## **ADDENDUM NO. 1 - OUTLINE AND SUMMARY INFORMATION**

Project Name: Julia Martin Stairs PPA No.: 22-0656  
Location: Montana State University - Bozeman Date: 12/20/2023  
Owner: State of Montana, MSU - Bozeman  
Plew Building 6<sup>th</sup> and Grant, PO Box 172760  
Bozeman, Montana 59717-2760

# EXHIBIT 1 - ORIGINAL FOUNDATION PLAN

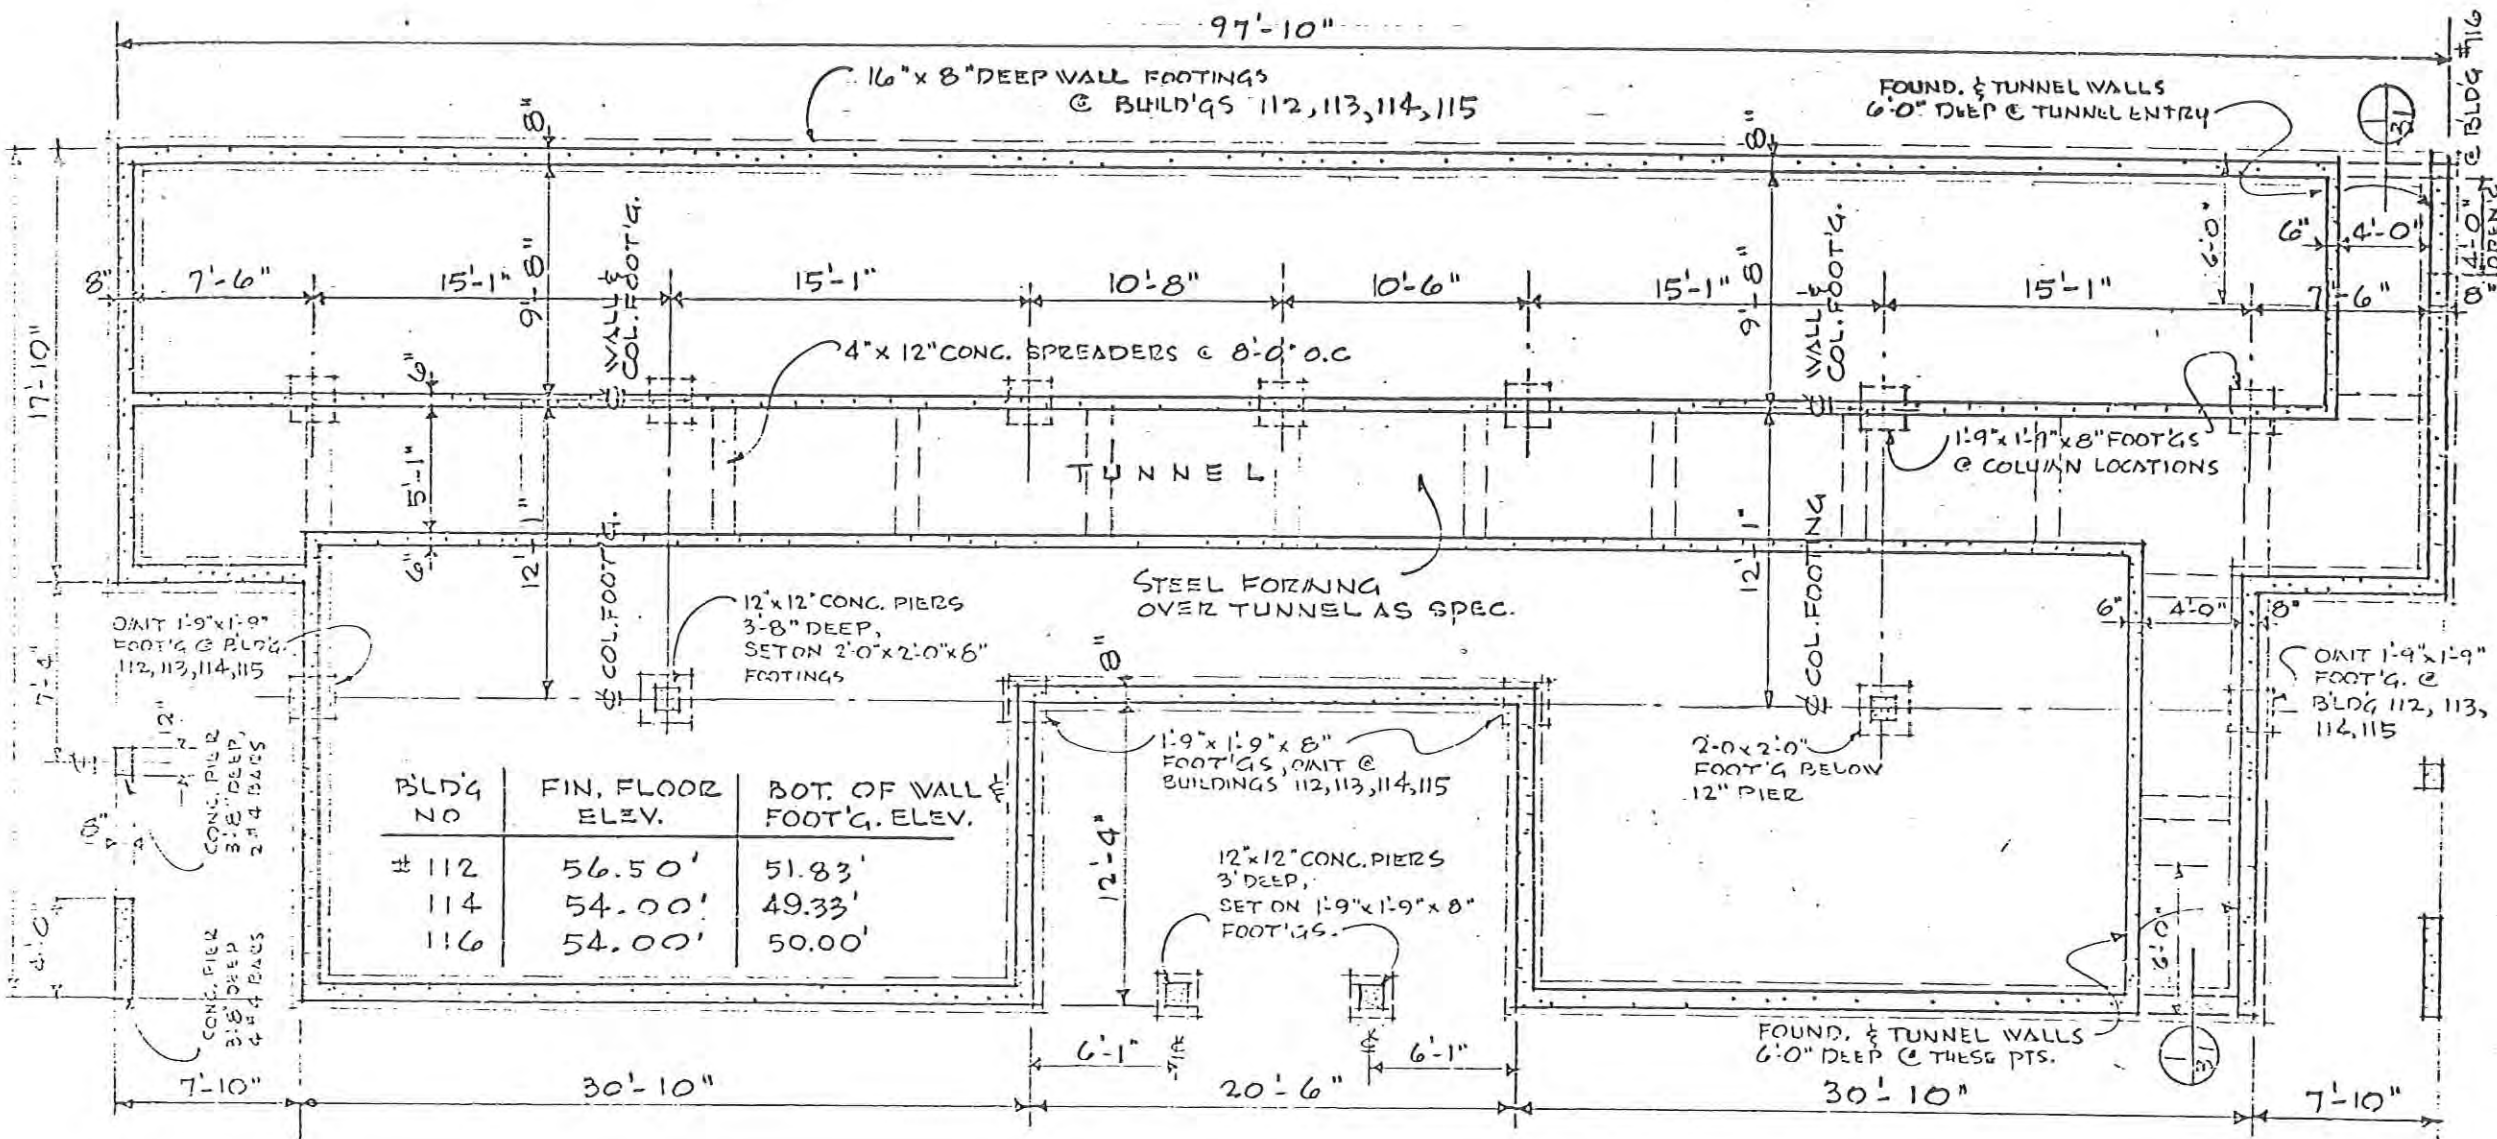
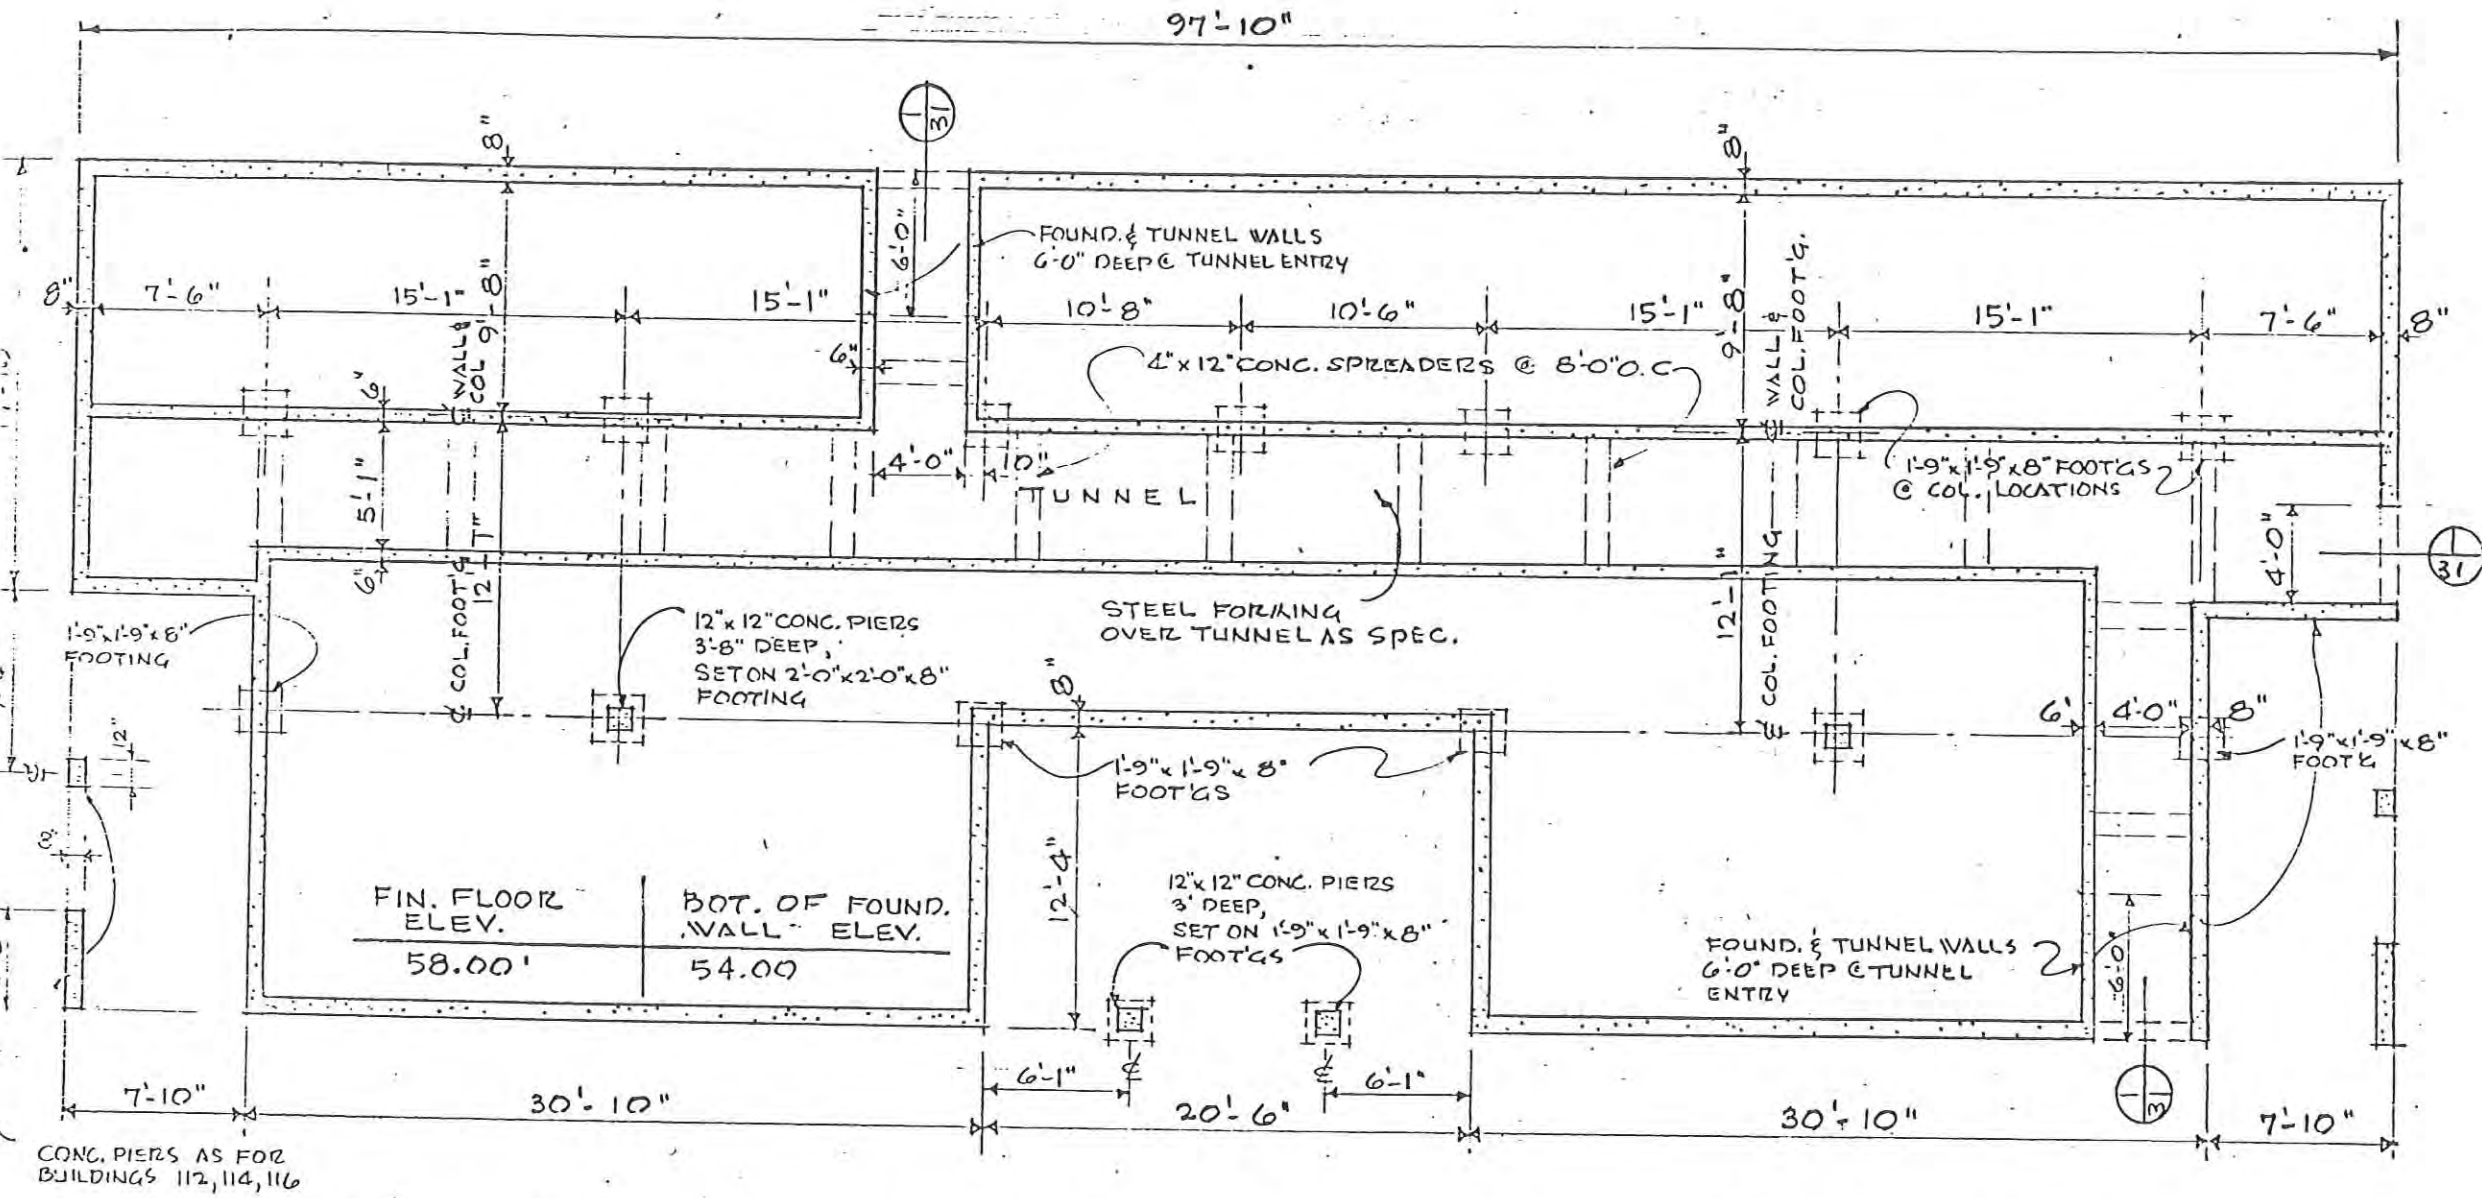
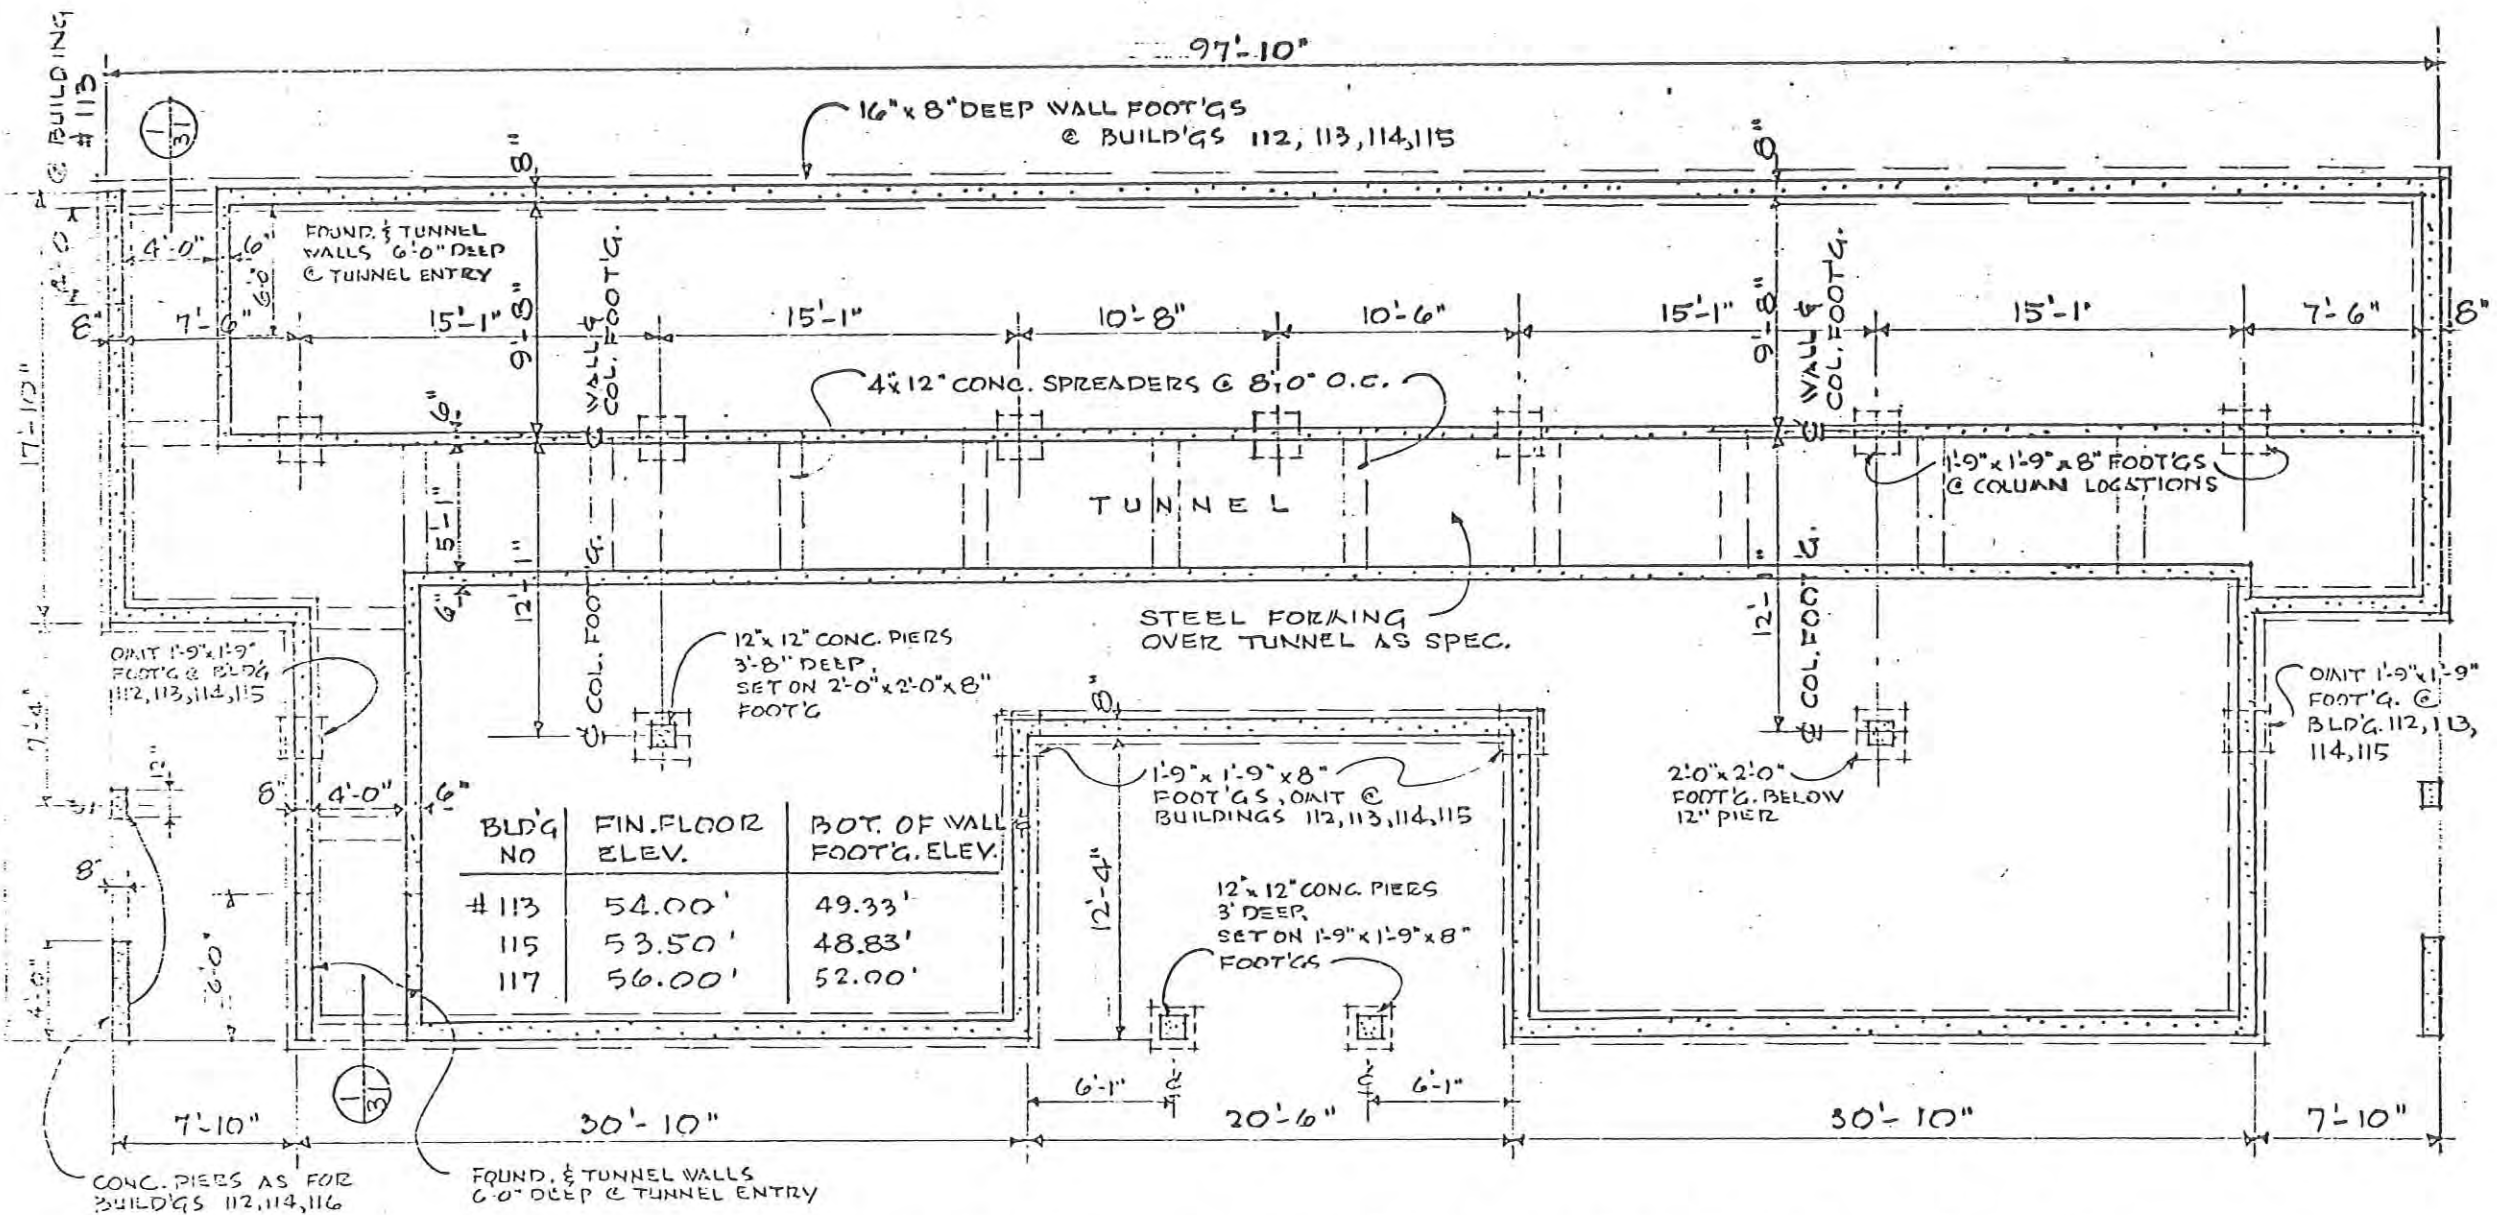
- xii. QUESTION: Are there as-builts/details of the existing slabs/foundations below the stairs?  
RESPONSE: We do not know if the plans we have are as-builts or construction drawings, but the foundation plans have been extracted and are attached as Exhibit 1. These are for reference only and are not to be considered as-built conditions.
